VEPCO NOMAD CODE AND MODEL SUPPLEMENTAL INFORMATION.

Docket # 50-280
Control # 8407170305
Date 7/6/84 of Document:
REGULATORY DOCKET FILE

RESPONSE TO QUESTIONS AND COMMENTS ON VEPCO NOMAD CODE AND MODEL (VEP-NFE-1)

FIGURE 4.8

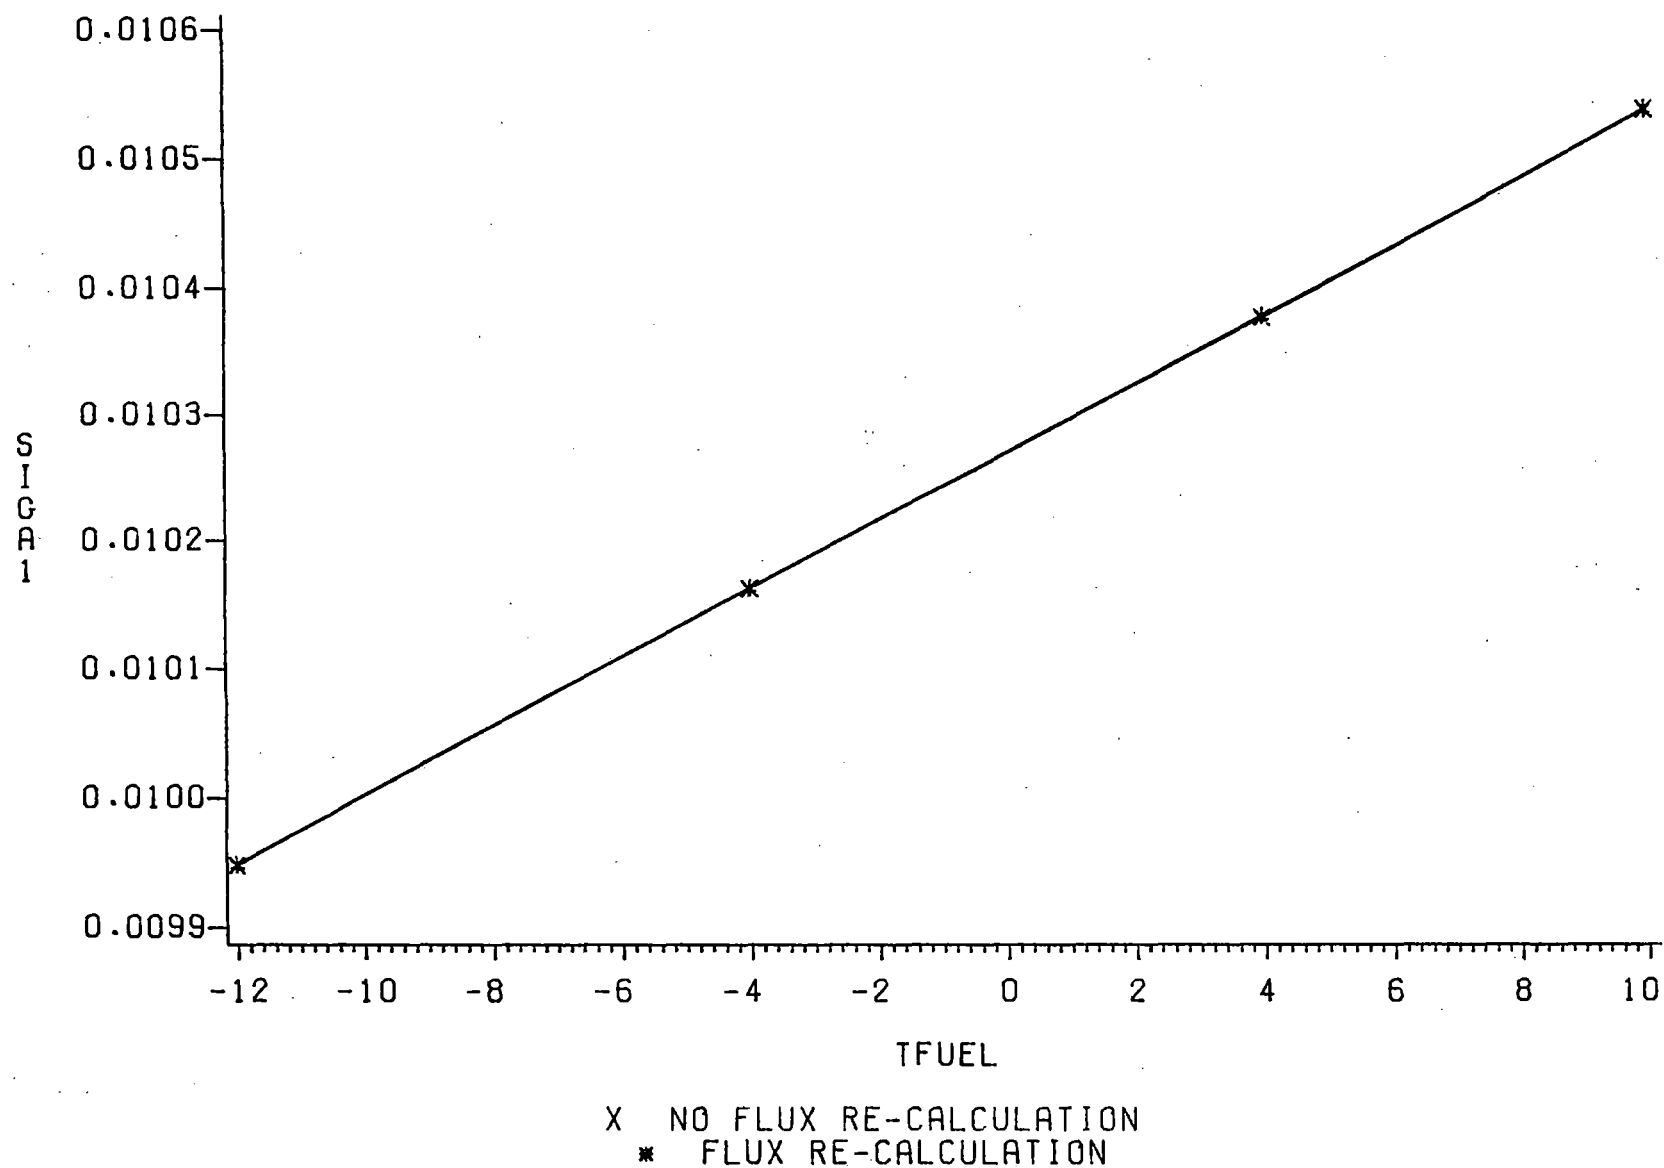
Question 4. The use of re-edits which do not involve flux calculations for off-nominal conditions is a feature of other procedures (e.g., ARMP). However, those procedures are usually concerned with long term burnup analyses. The adequacy of this type of treatment for some of the NOMAD applications should be justified.

A series of restart flux and eigenvalue calculations were performed with the PDQ07 One Zone model at one burnup step. The macroscopic cross sections obtained from these calculations were input to the XSFIT and XSEXP codes to calculate the cross section coefficients in accordance with the procedure described in Response to Question No. 3 above. The macroscopic cross sections predicted with these coefficients are compared to similar results using the normal methodology without flux re-calculations for off-nominal conditions in Figures 4.1 through 4.31. The results are virtually identical for most cases, and the maximum difference for all cases is 0.1%.

FIGURE 5.1

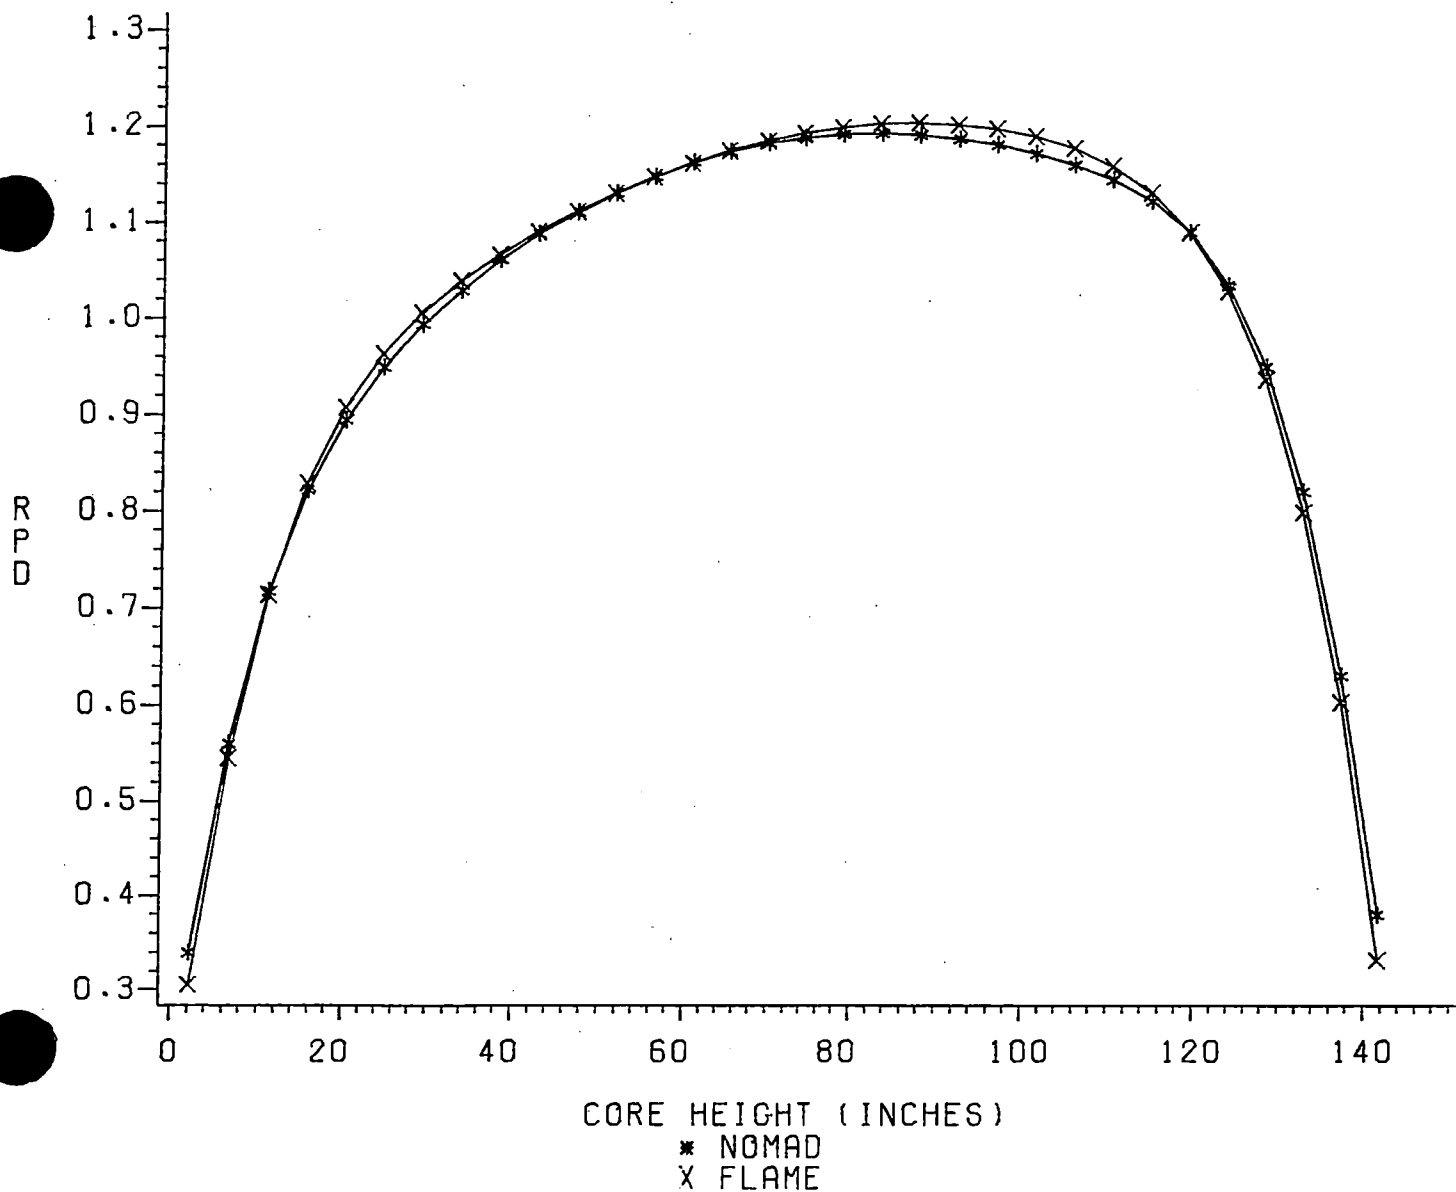
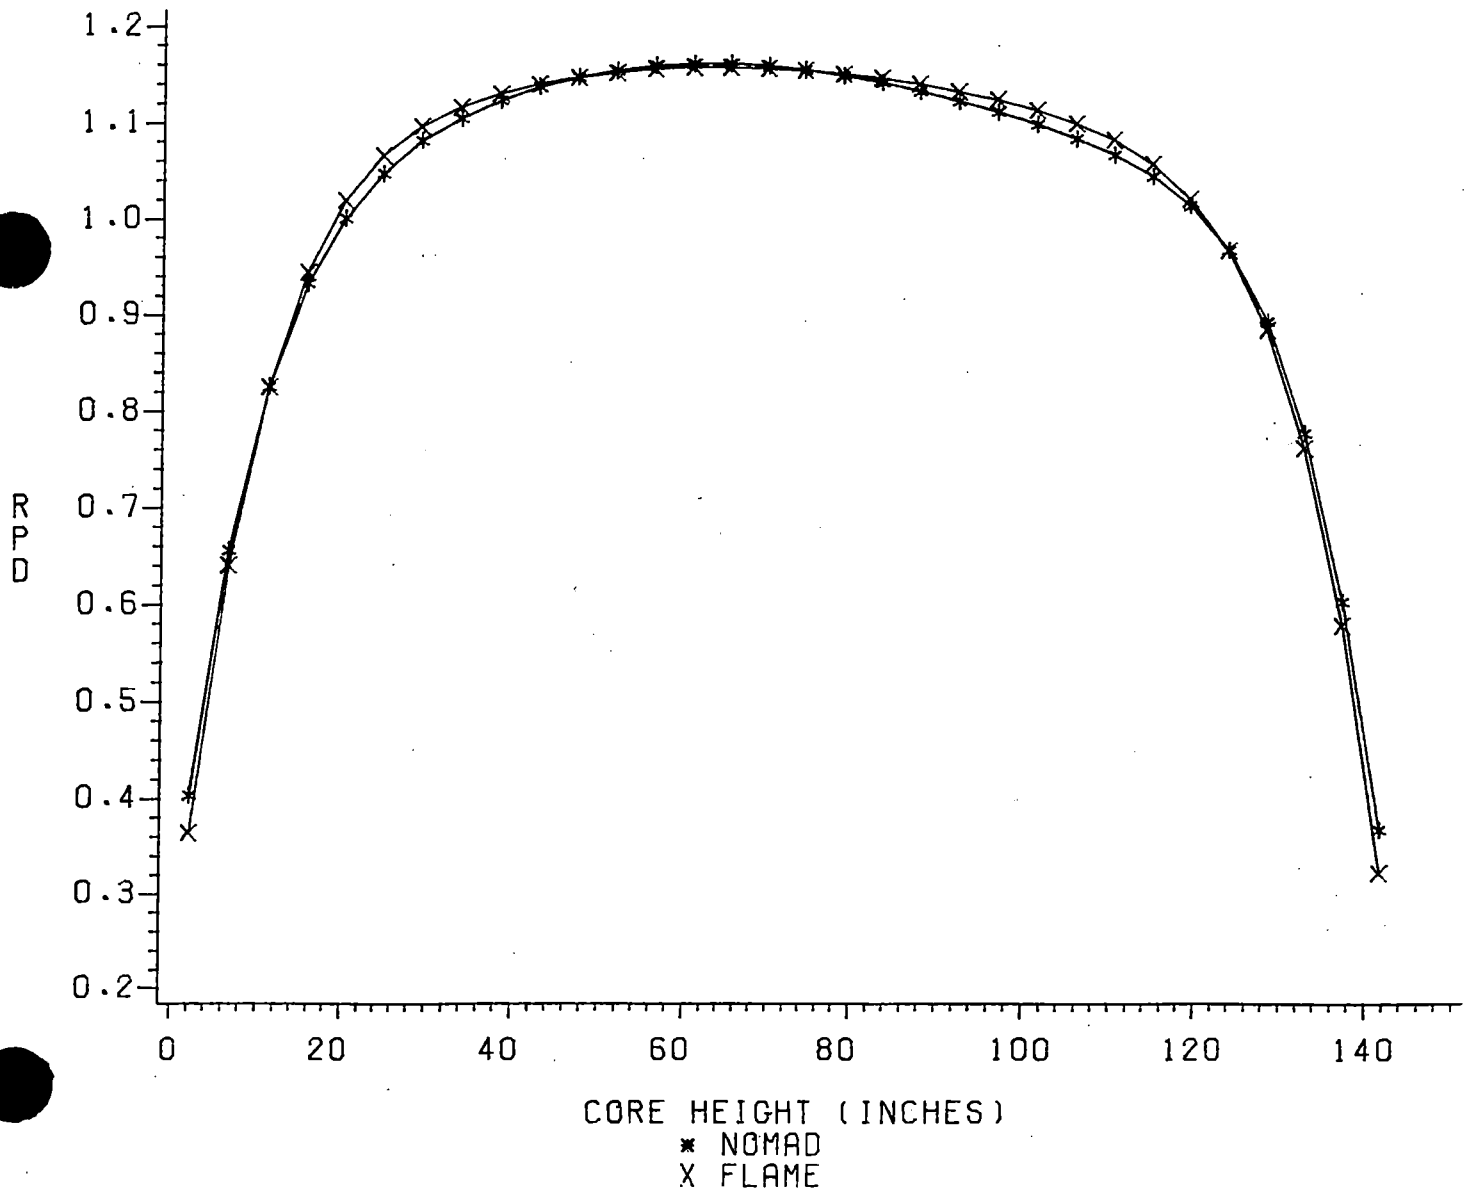
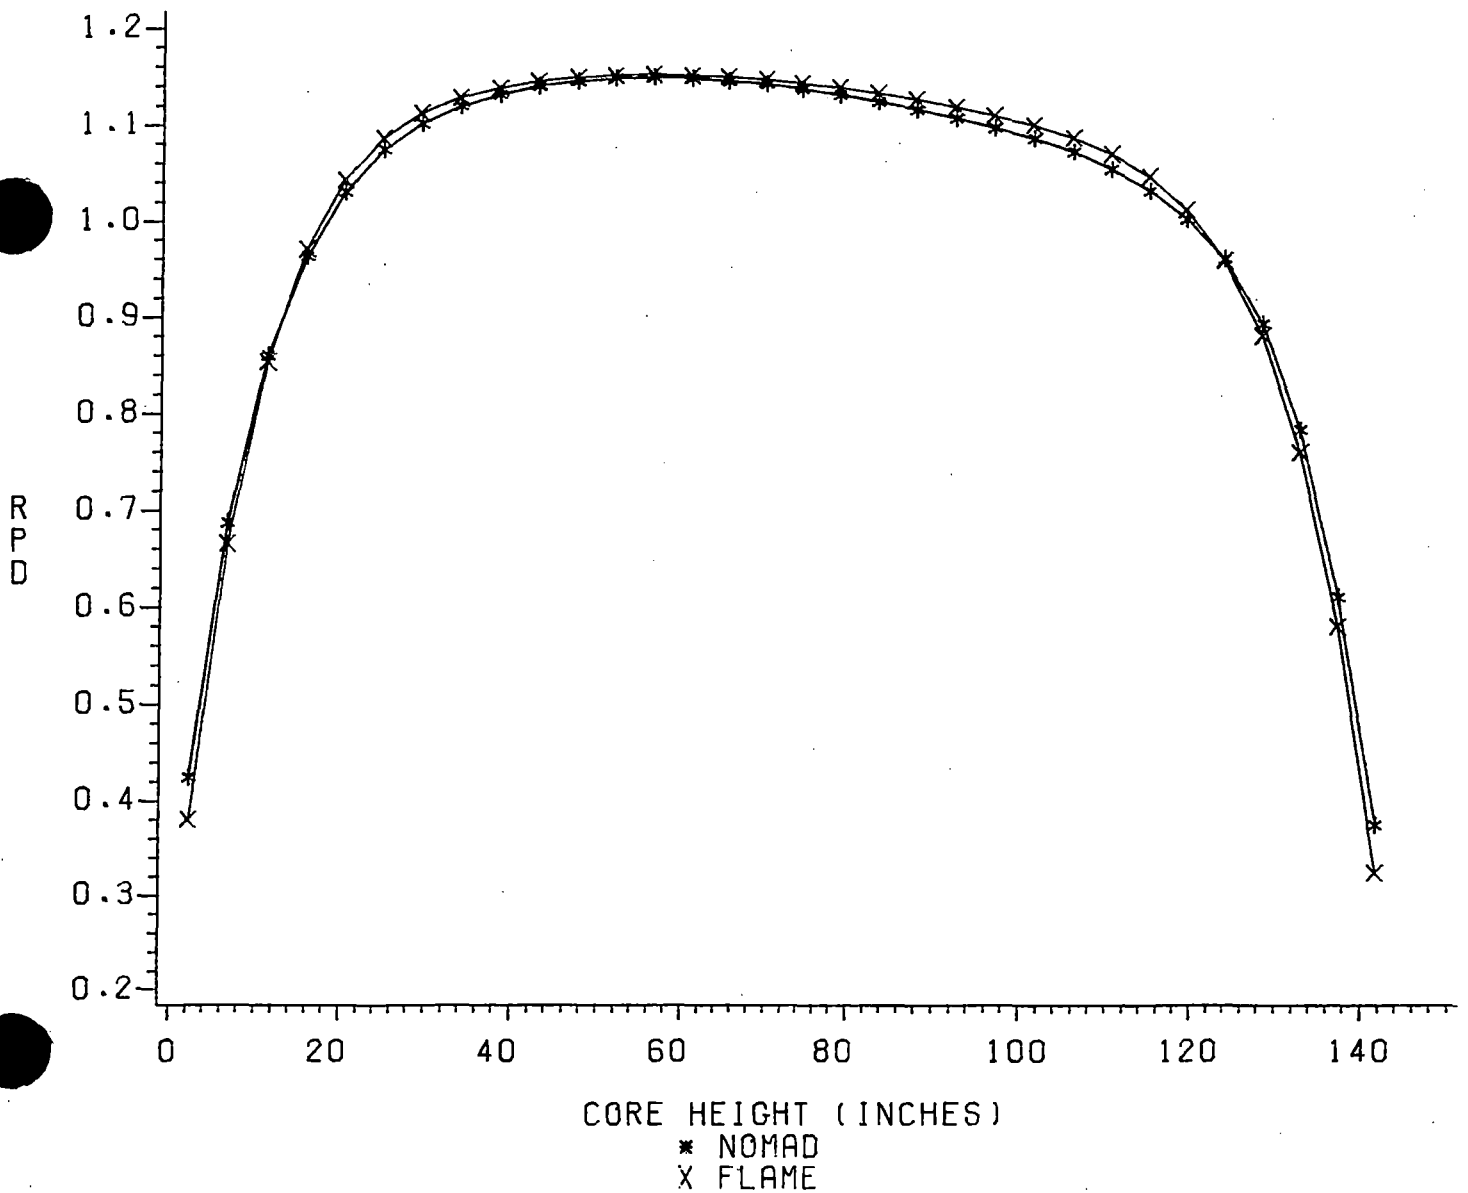
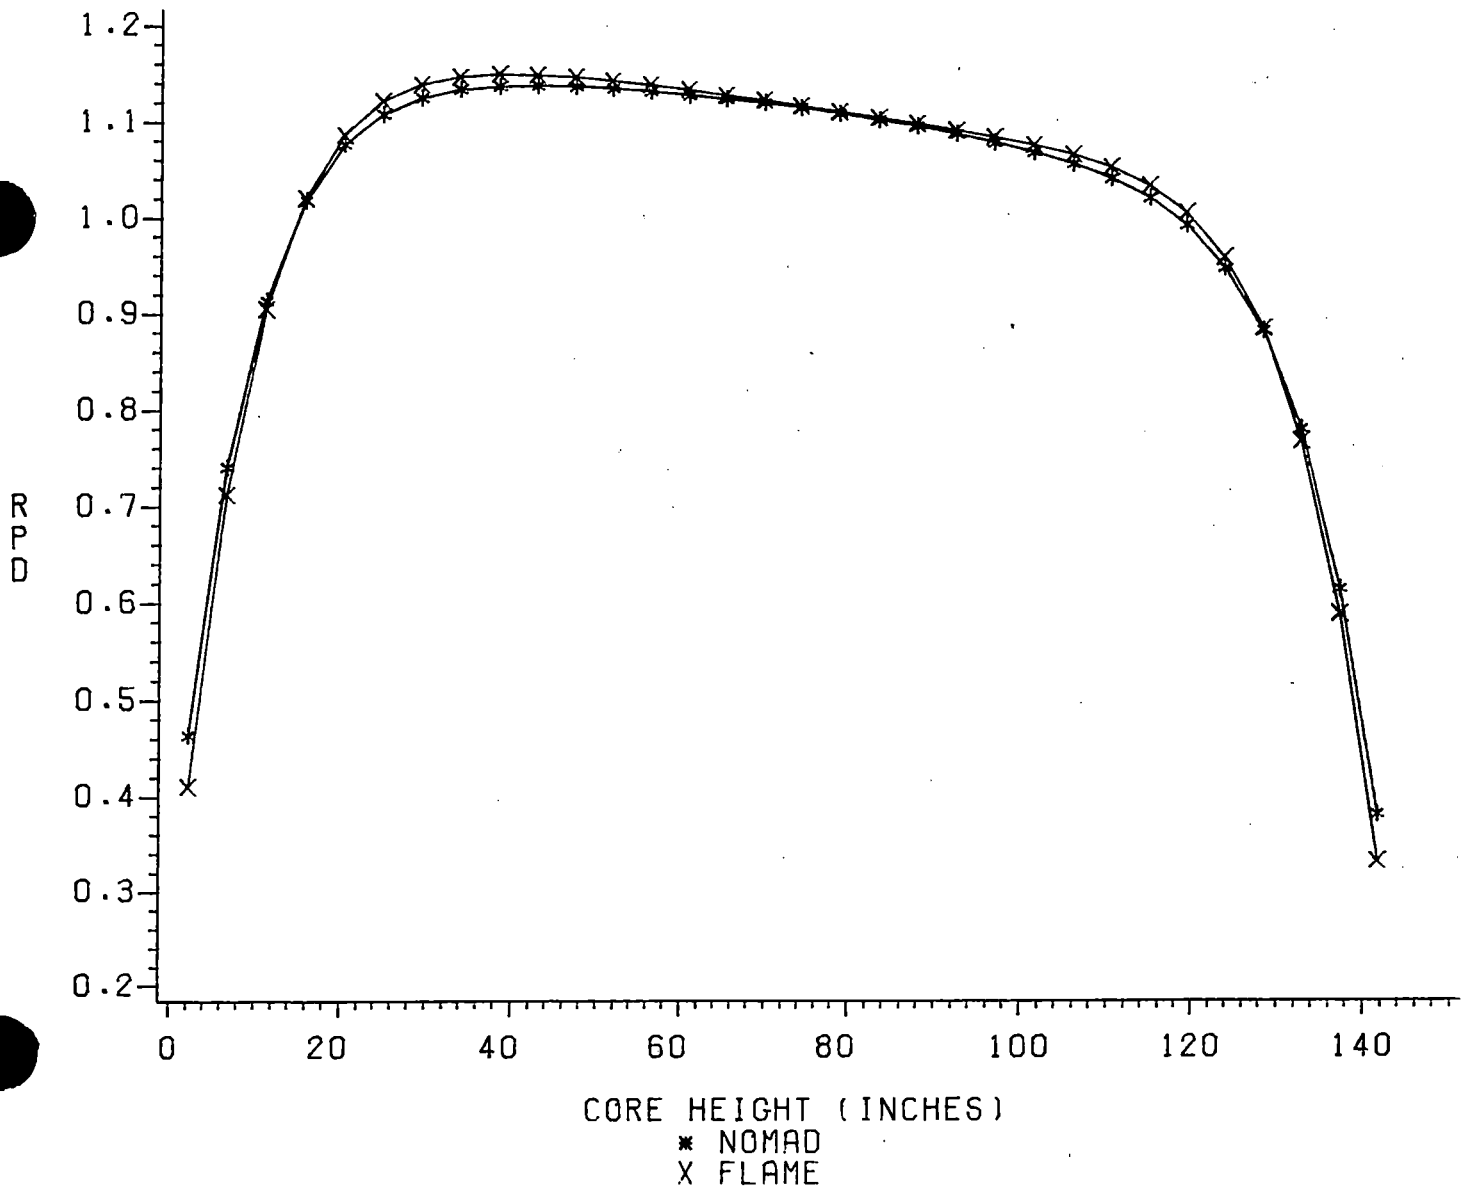
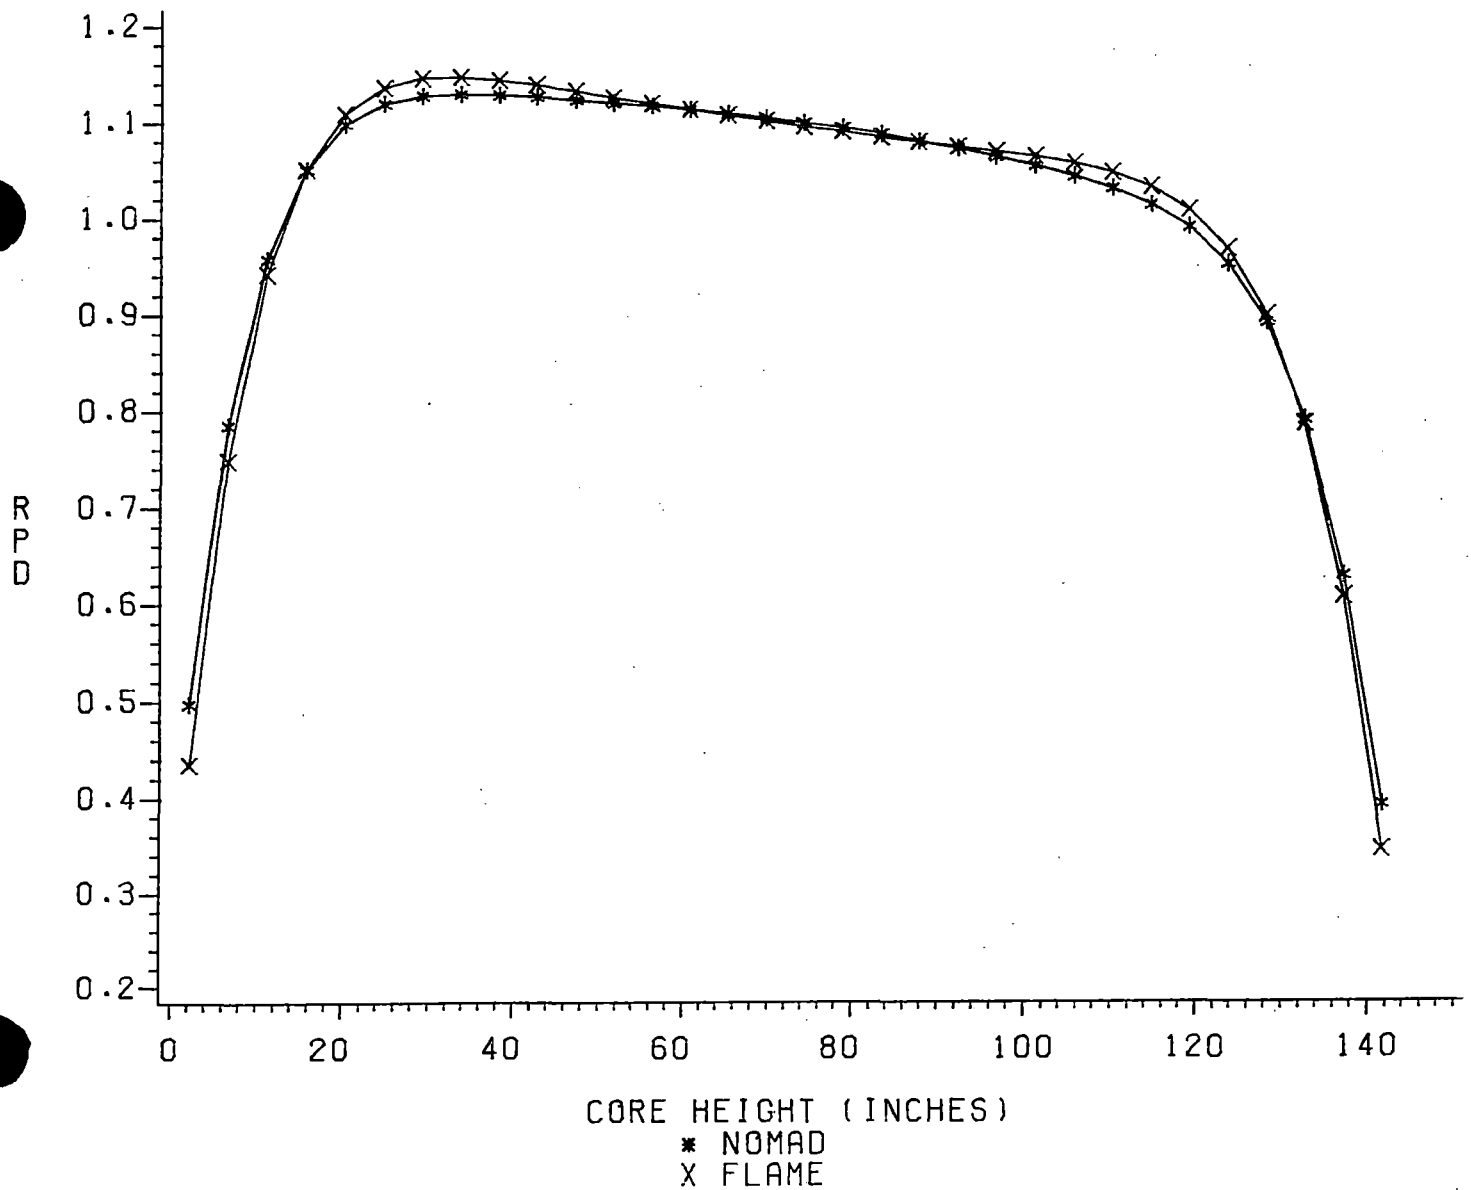
Question 5. The normalization of NOMAD to FLAME solely on the basis of flux difference and mid-plane power in the buckling search seems too limited. In addition, performing the buckling search for rodded configurations with the xenon distribution "frozen at HFP, ARO equilibrium conditions..." does not sound like the right way to do this.

VEPCO's experience has been that axial offset, midplane power and critical boron are sufficient conditions for normalizing NOMAD to FLAME. This is very similar to the 1-D to 3-D normalization methods used by some vendors. Comparisons of NOMAD and FLAME axial power distributions for every burnup step of S1C7 are presented in Figures 5.1 through 5.11. The maximum difference between NOMAD and FLAME is 2.9% for these cases.
